PROPOSED ROADWAY PLANS FOR JUDGE ORR ROAD RV PARK & STORAGE EL PASO COUNTY, COLORADO

APRIL 2022

PDC PROJECT # CDR-22-002

URBAN RESIDENTIAL COLLECTOR ROADWAY DETAIL
N.T.S.

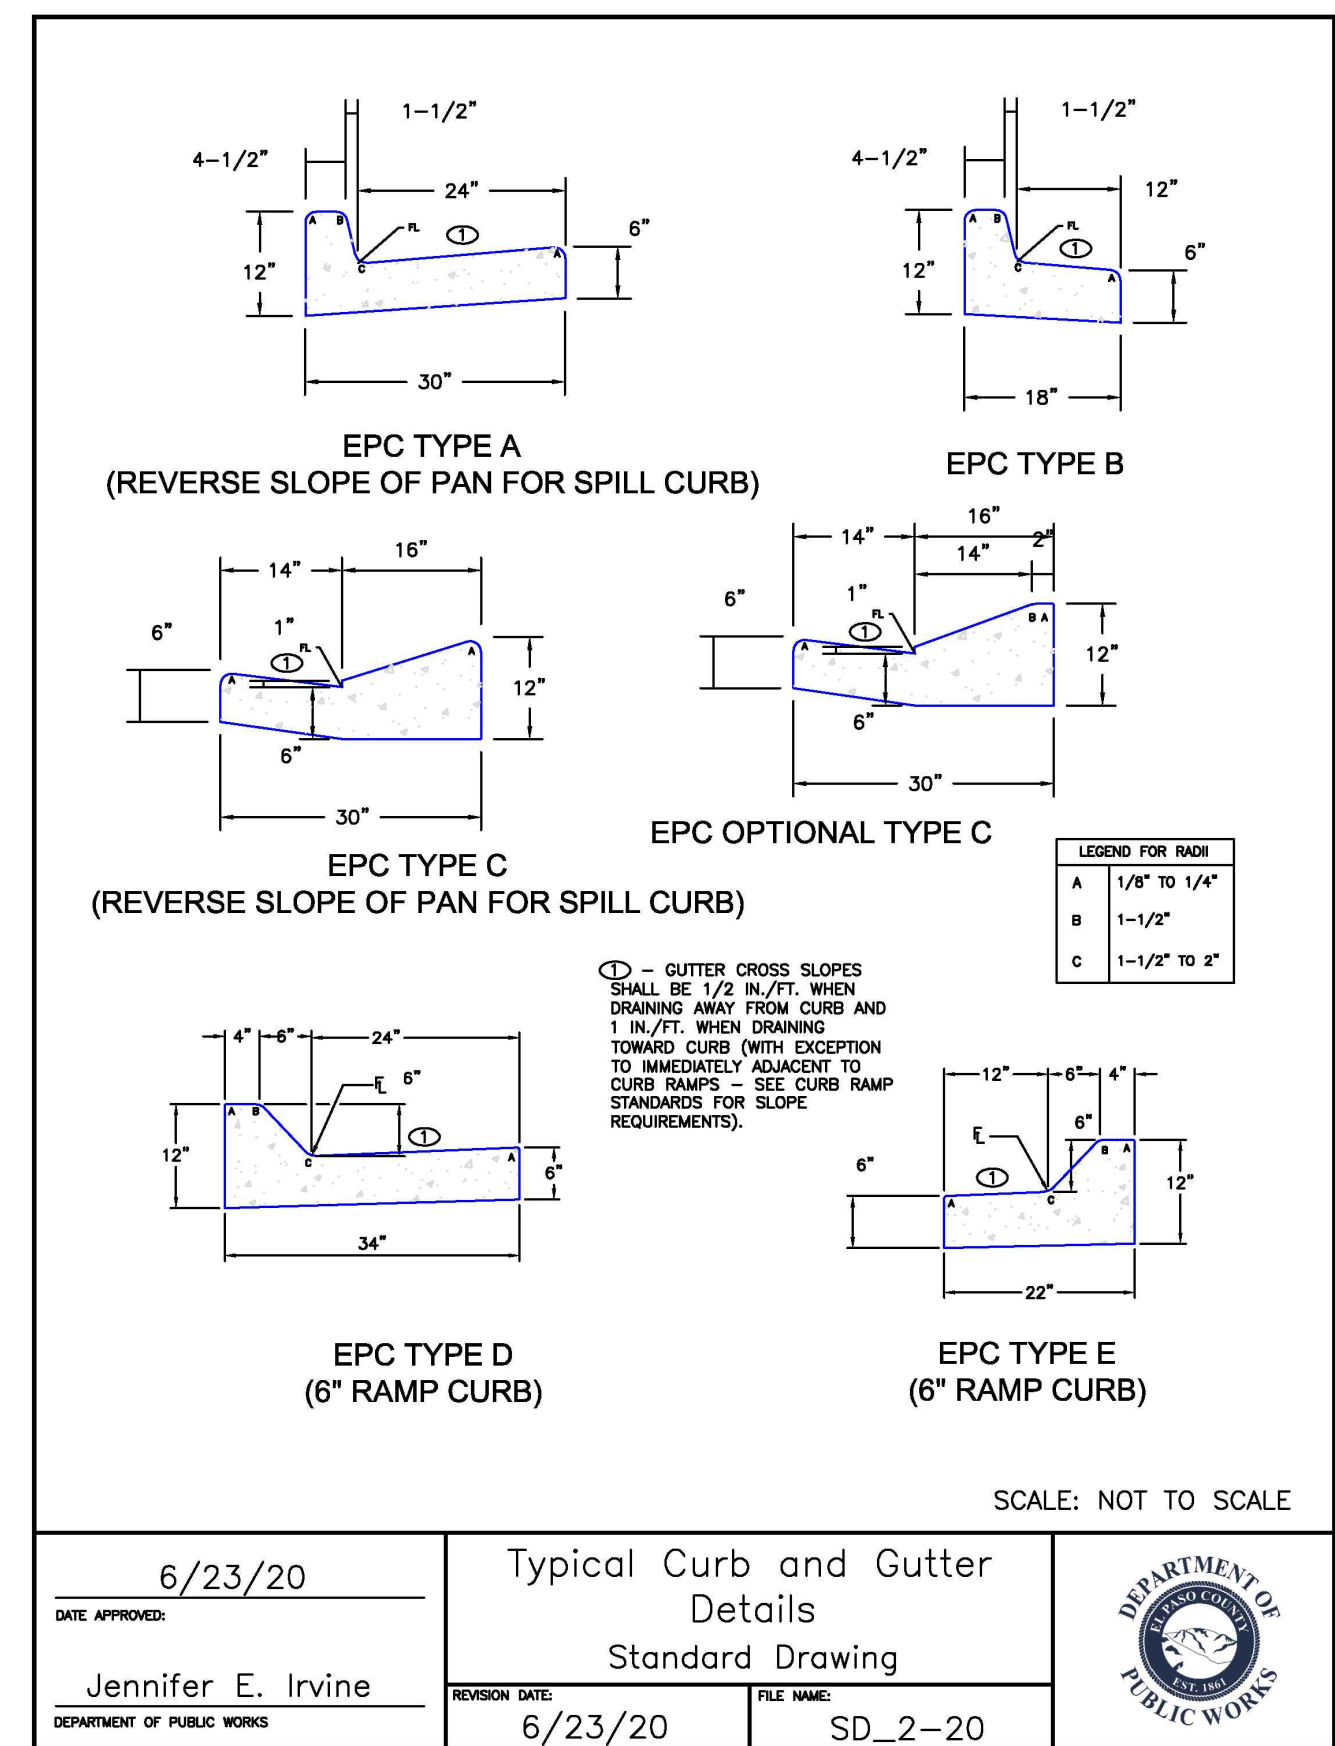
Please replace urban residential collector with SD 2-3 Urban Non-Residential Urban Collector

SHEET TITLE: ROADWAY OVERALL NOTES & DETAILS

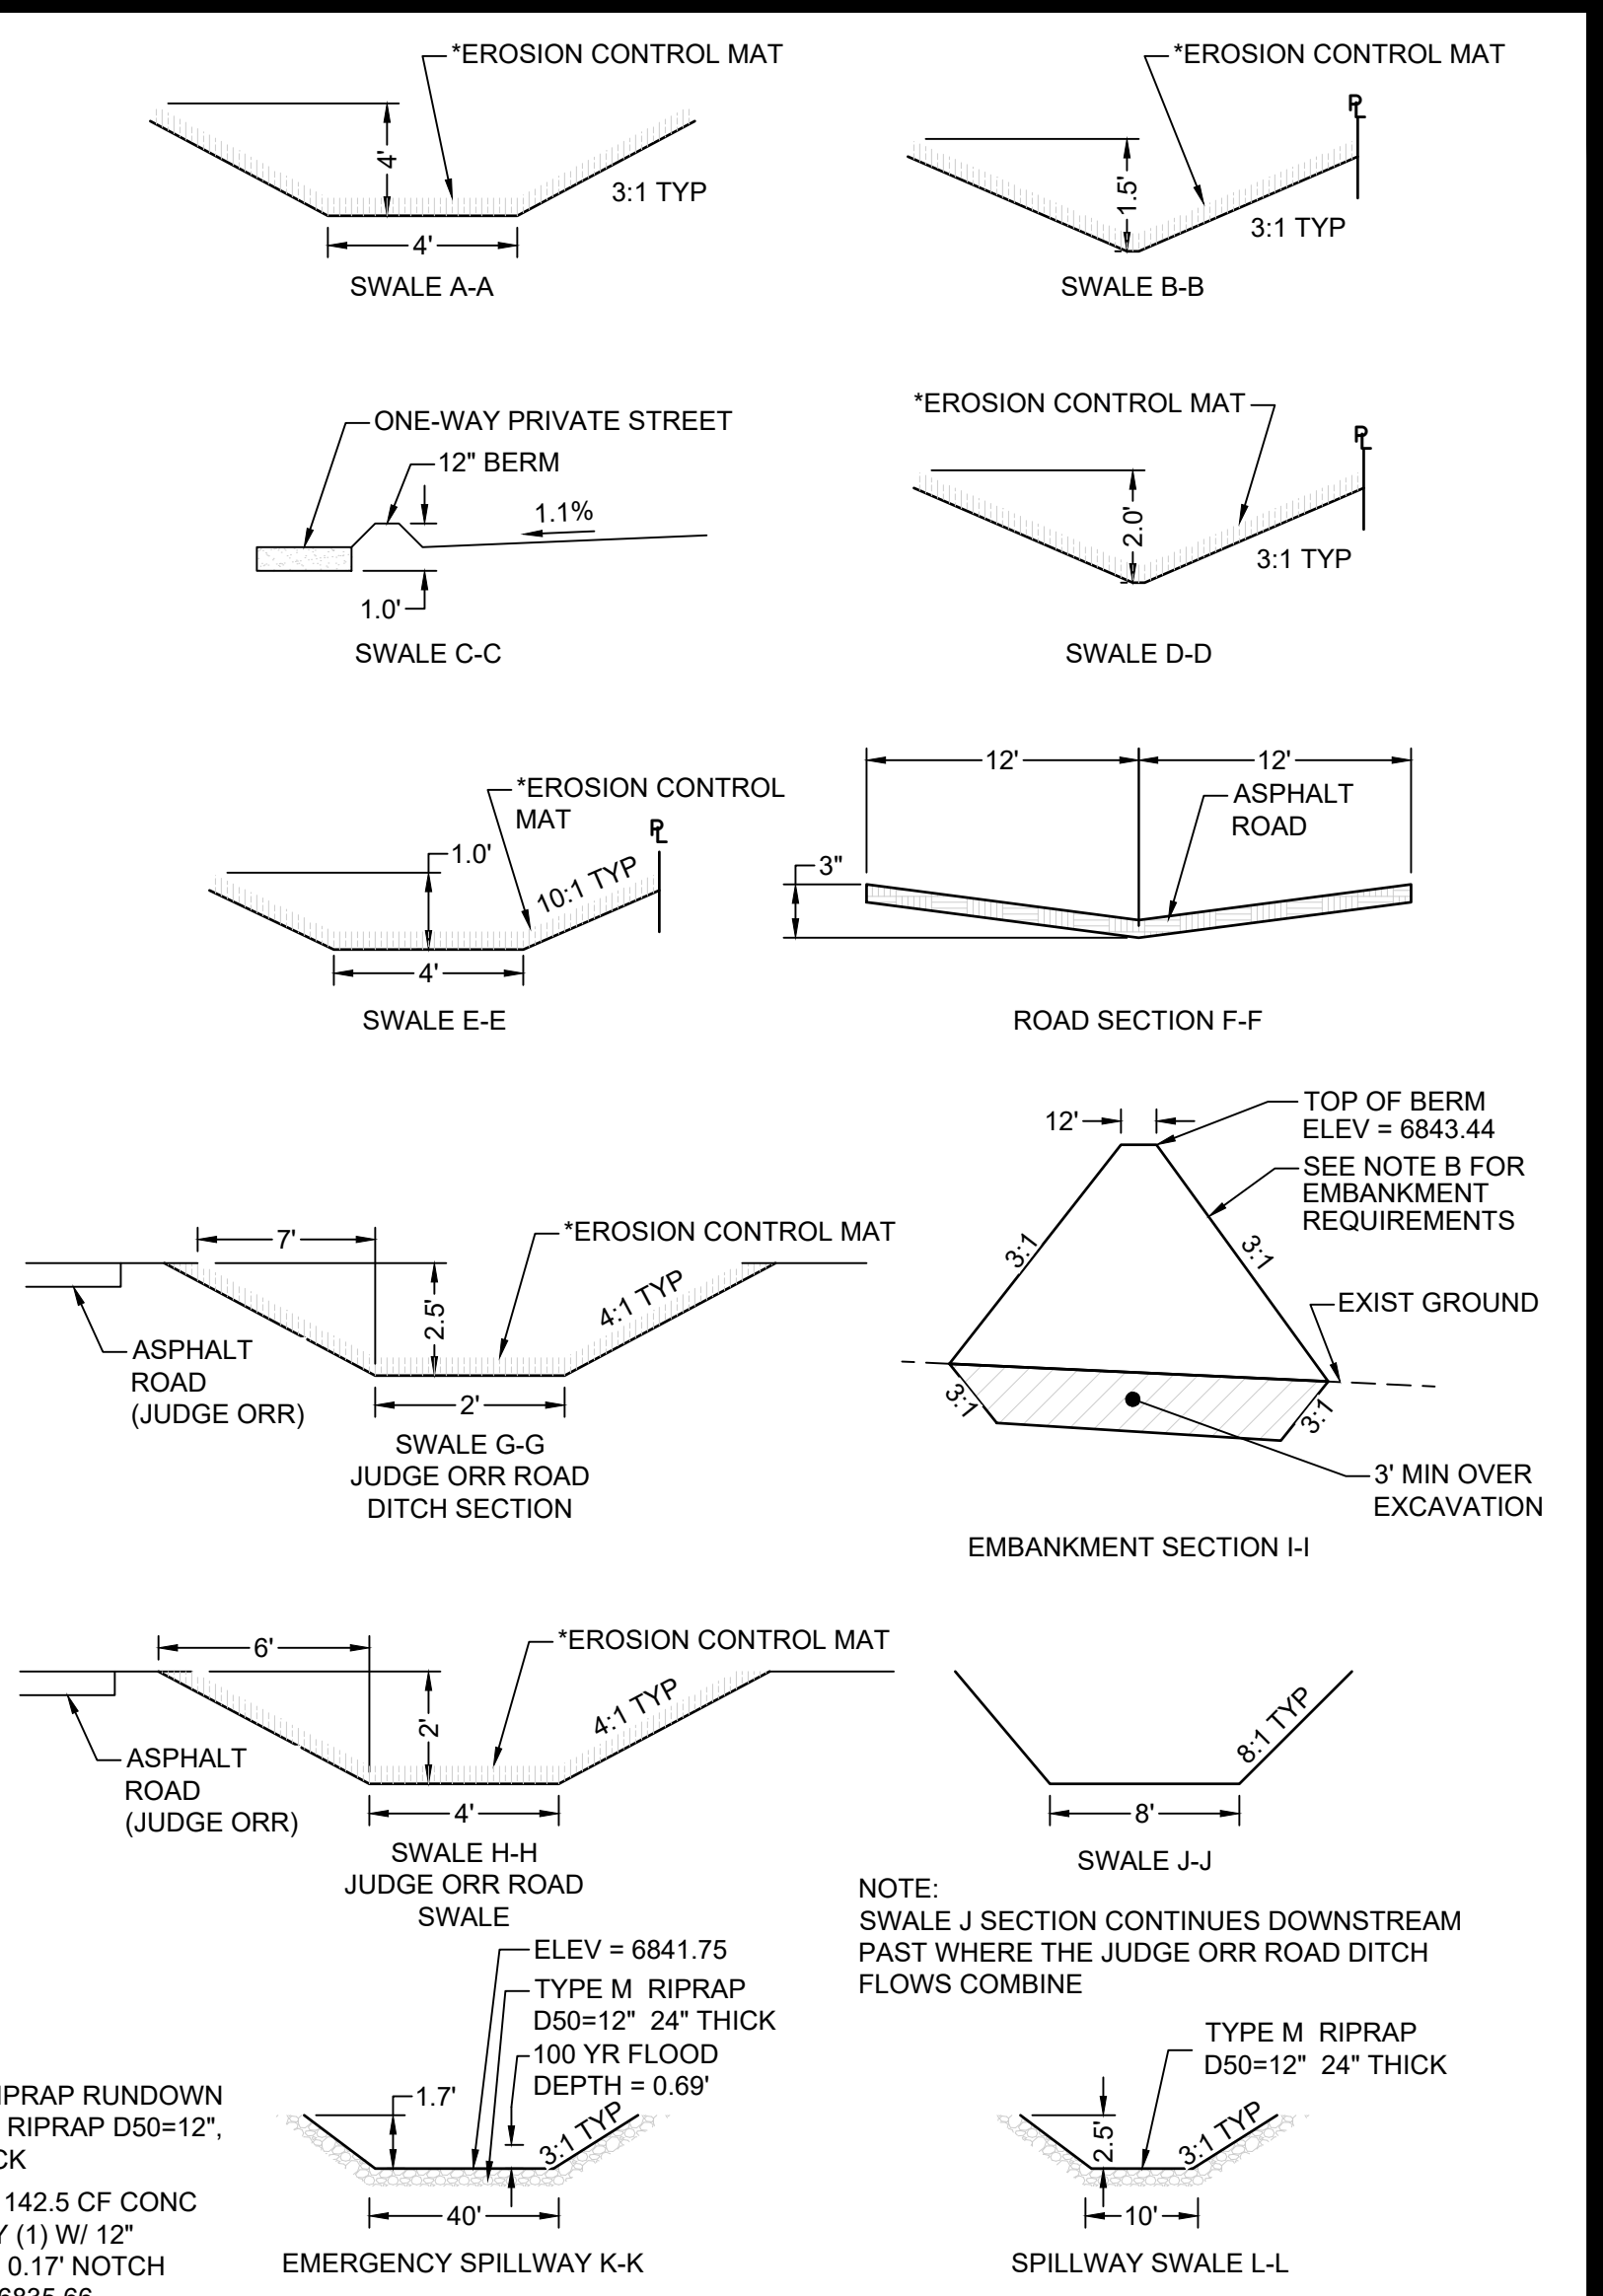
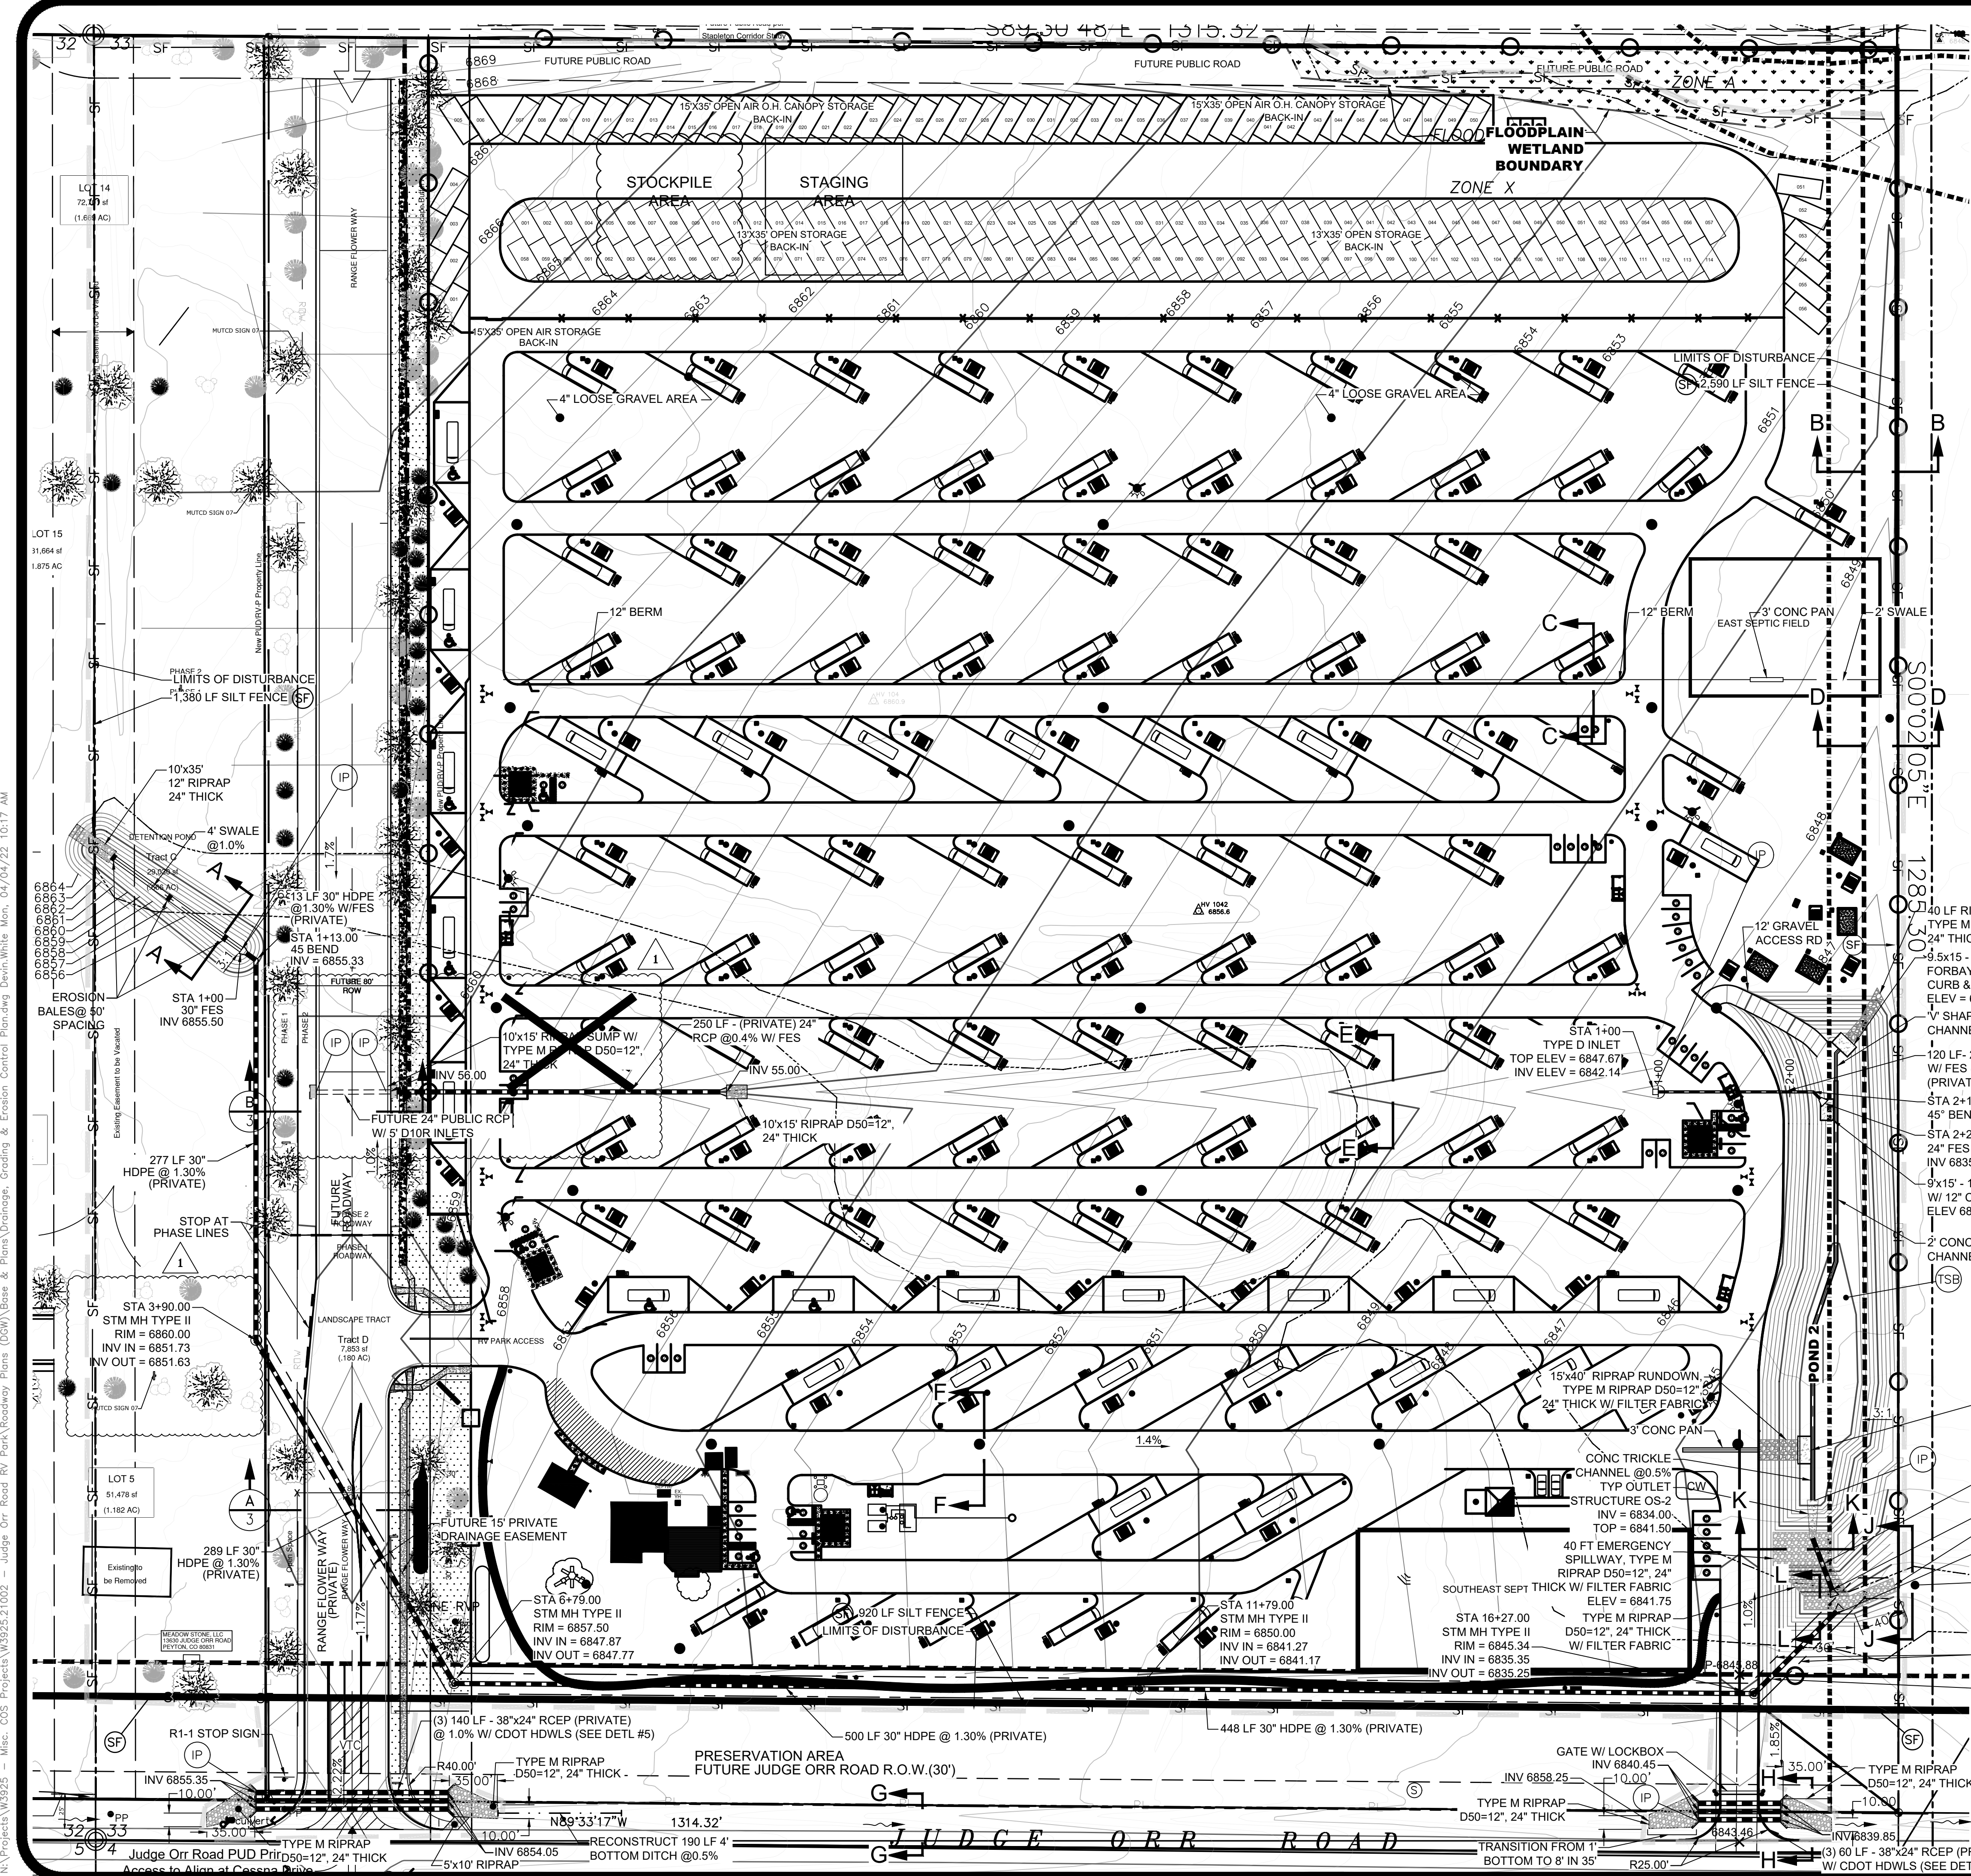
Add note on sidewalk
 Future Sidewalk on West side of Range Flower Way (Private)

Please add note or add SD-2-42 drawing
